A117.1 2003 errata

1 March, 2007

13 December, 2005

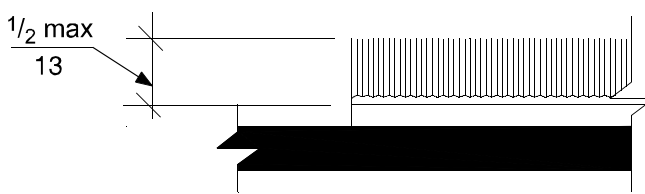
- Page VI: In the third line of the last paragraph, the reference should be to the “ICC A117.1-2003” instead of to the “ICC 300-2002.”
- Page IX: The number of professional members on the committee is 13 instead of 8. This also results in a total of 43 members instead of 38.
- Page 2: The figure should be labeled as “Fig. 104.3” instead of “Fig 104.2.”
- Page 7: Figure 302.2 should have the dimension string modified so that it only measures the height of the carpet pile and does not include the backing/pad. Figure should appear as shown below.
